Project Name: Willow - Bid Package 2 – New Build

Project No.: 221125-090

Architect: Kingscott

This Addendum is issued to inform the bidders of modifications in the scope of work being bid for this project.

EQUIPMENT PLAN - UNIT 1100

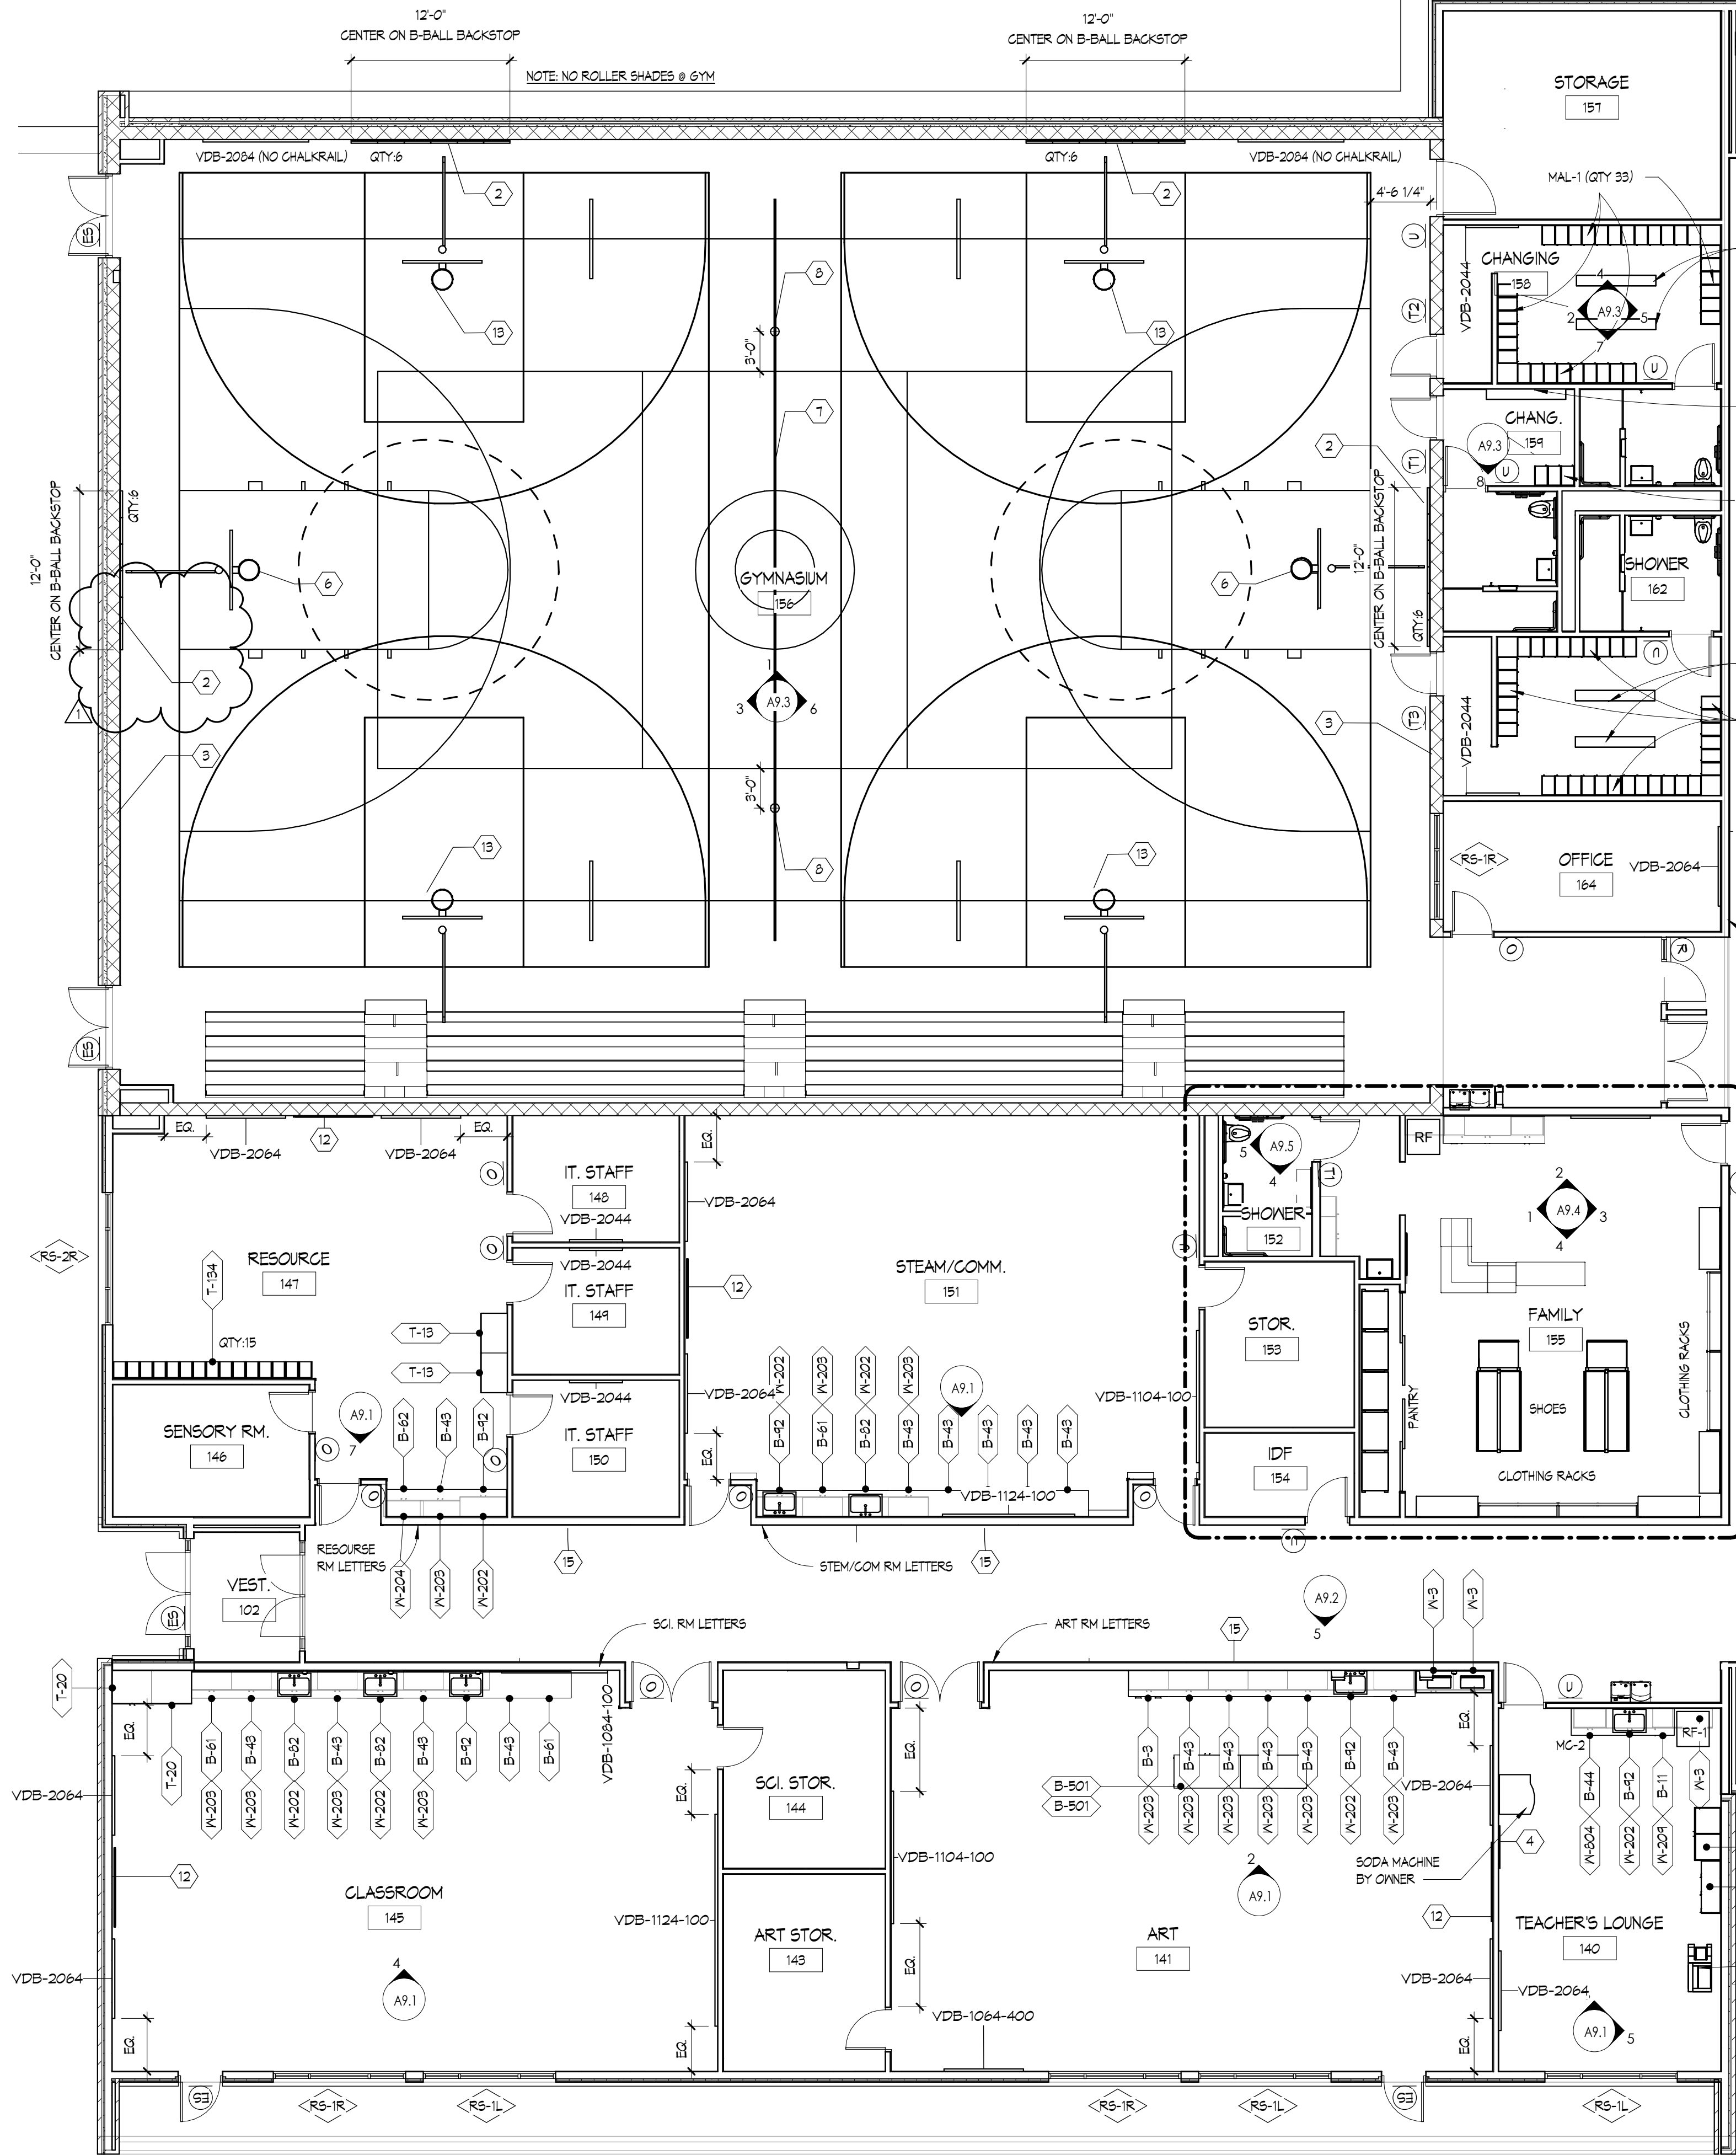
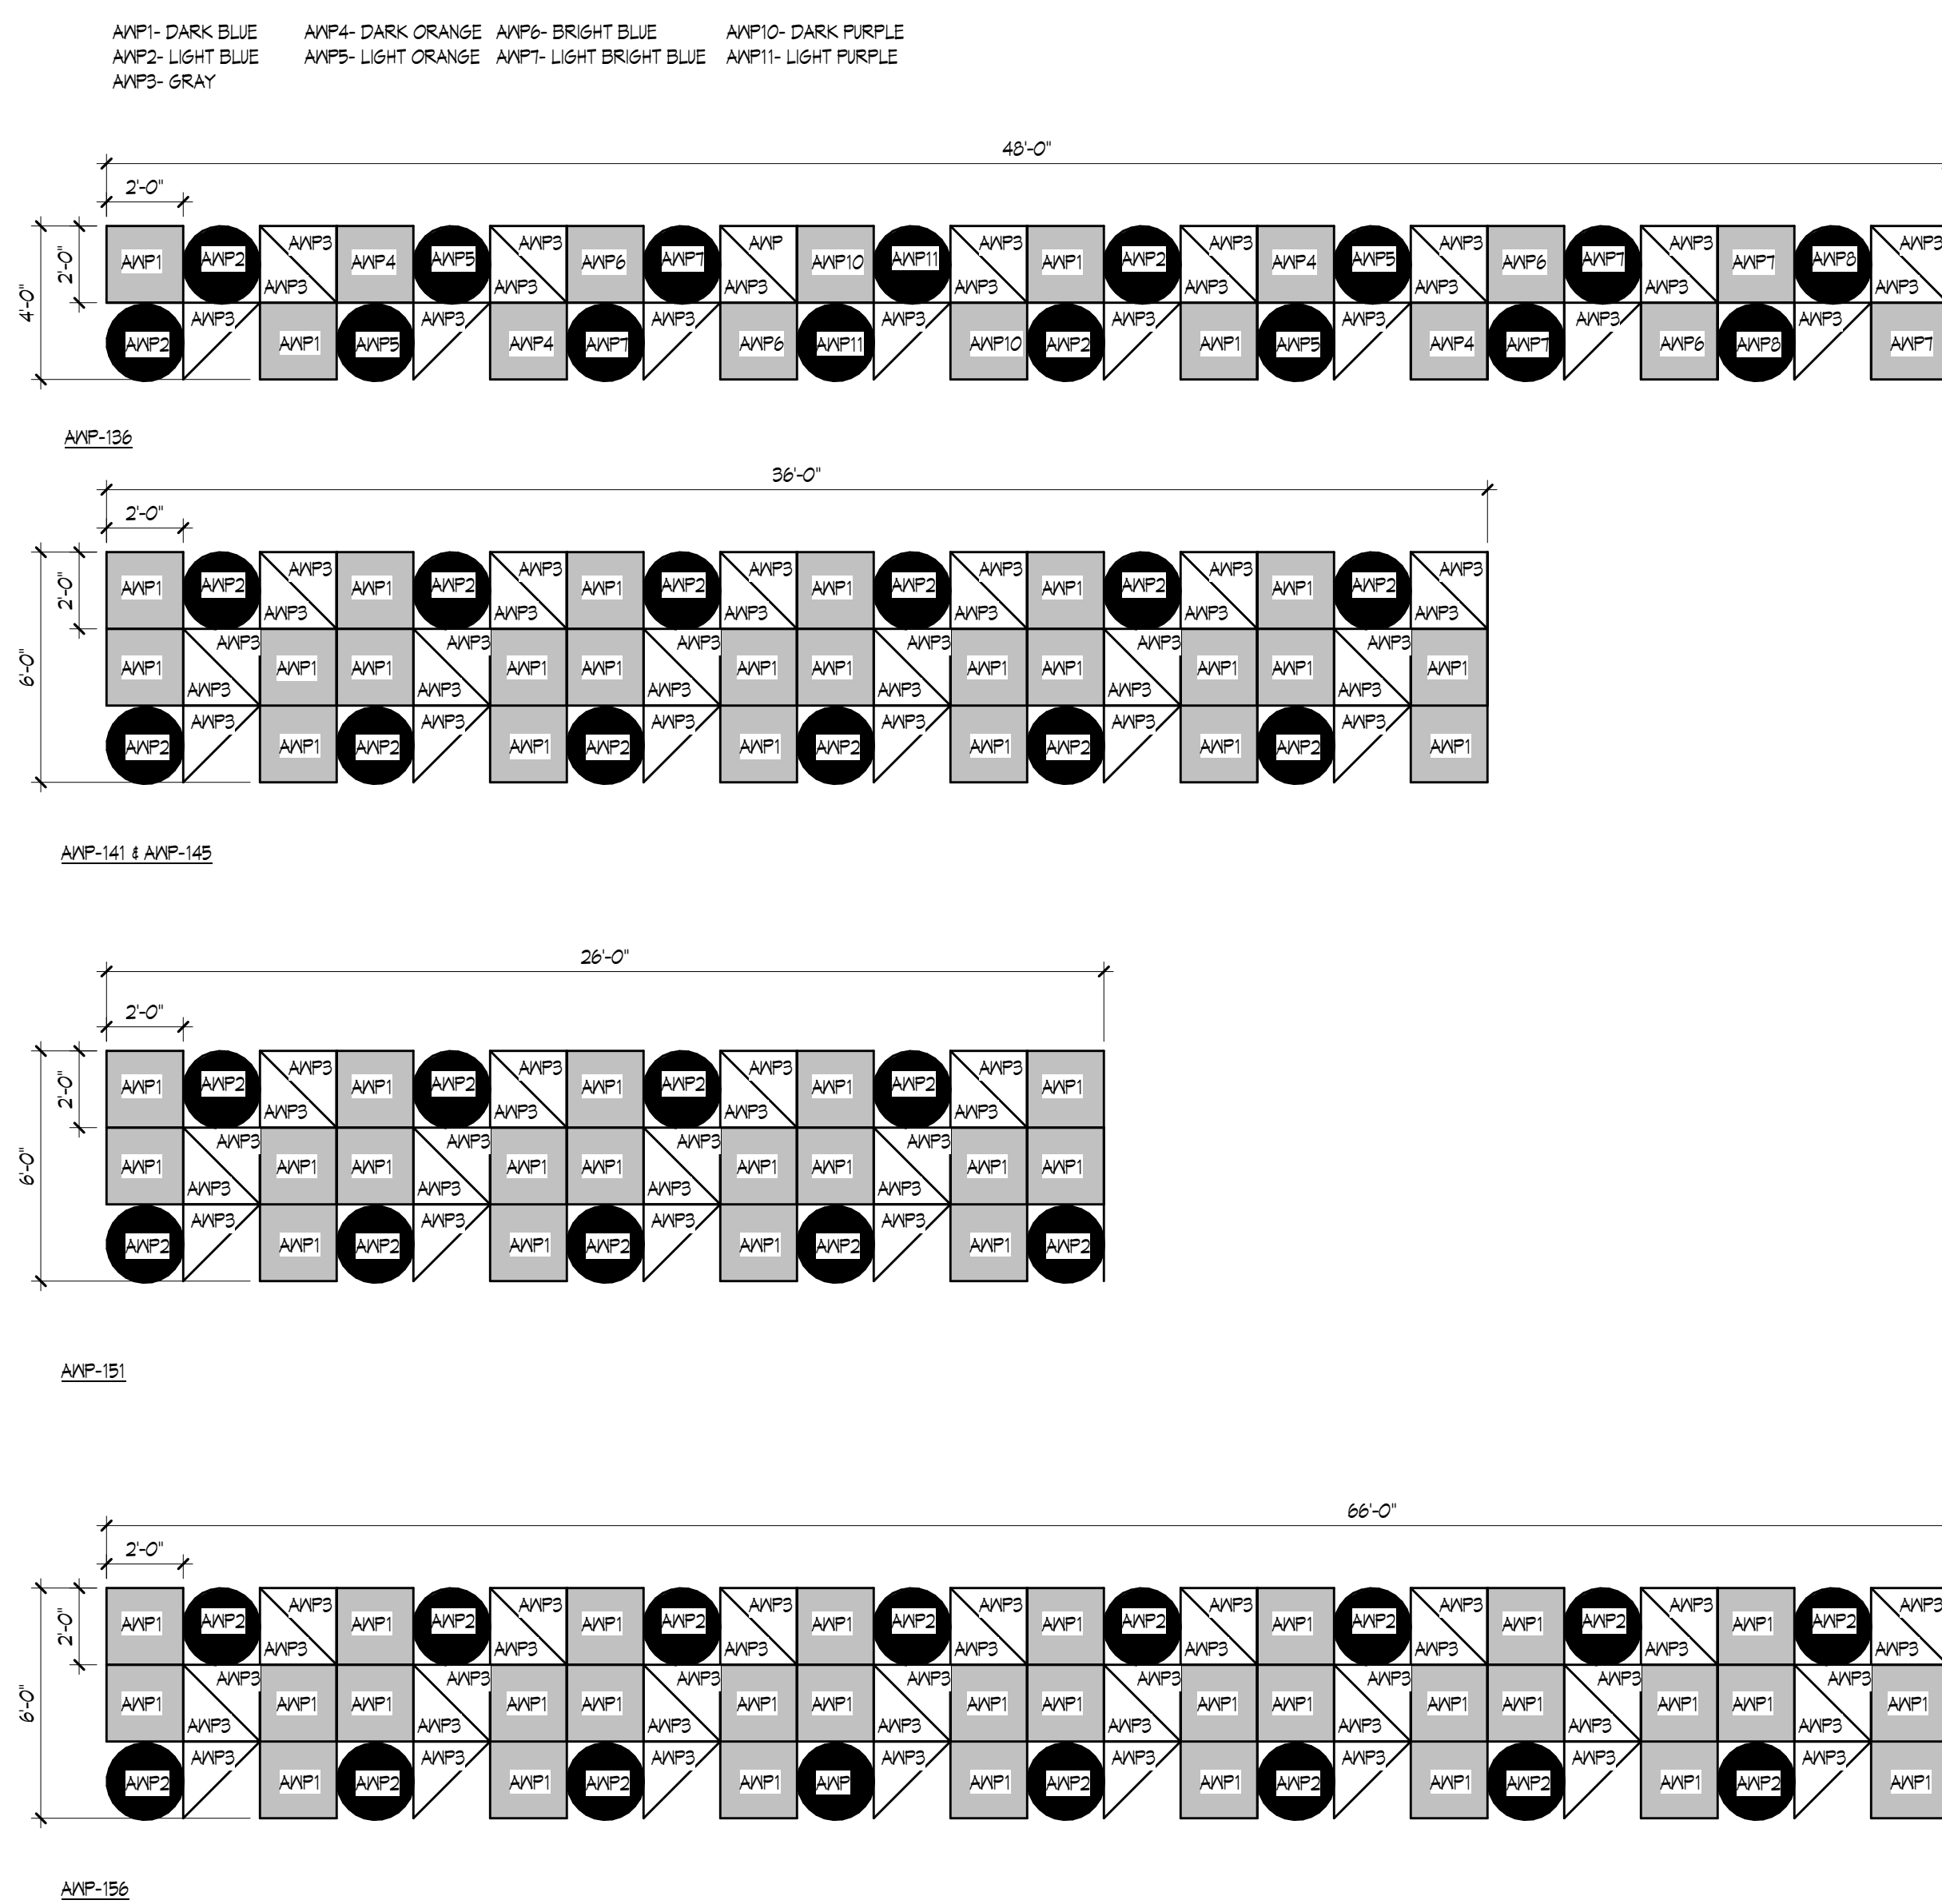
- Added additional scoreboard to gymnasium.
